ZONING ORDINANCE MODERNIZATION (ZMOD)

DESCRIPTION OF THE APPLICATION

Title of FDP: The Boro Buildings I and K

Figure 5: Proposed Development. Source: FDP (Sheet C-07) with Staff Annotations.

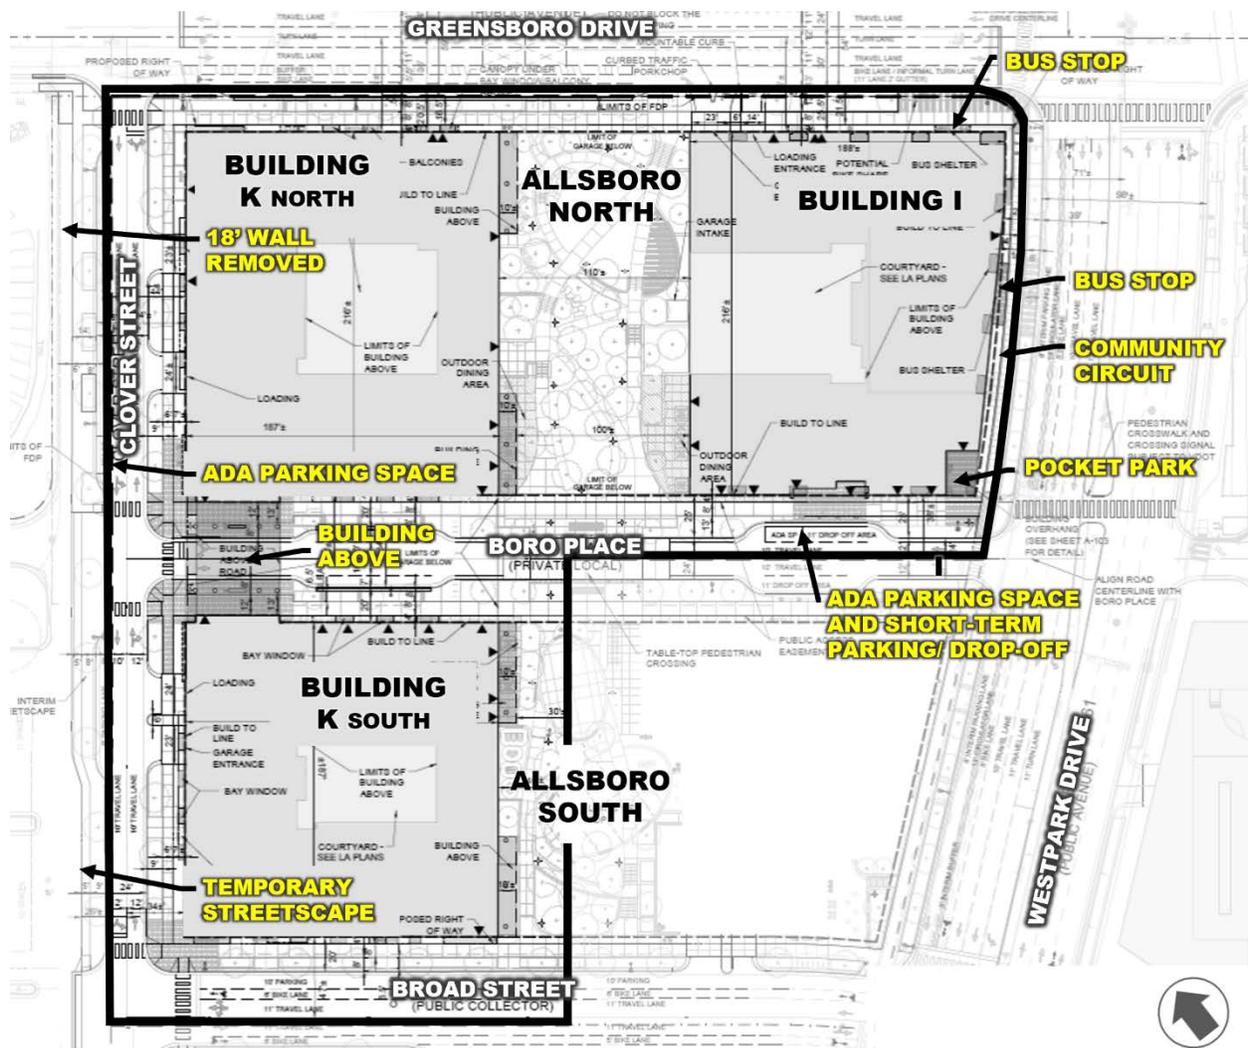
Boro Place is envisioned to be the main activity corridor of the site, lined with ground floor retail and restaurant uses. Boro Place would intersect new publicly accessible parks referred to herein as Allsboro North and Allsboro South (collectively Allsboro Parks). Allsboro North is located between Blocks I and K North, and Allsboro South is located between Blocks K South and Block J. Allsboro Parks would be the heart of the development and would be extensively landscaped and programmed with outdoor dining, performances, and amenities. A Tysons-wide recreational trail, known as the Community Circuit, is planned along the Westpark Drive frontage of Block I. *Figure 5* above depicts the proposed development scheme.
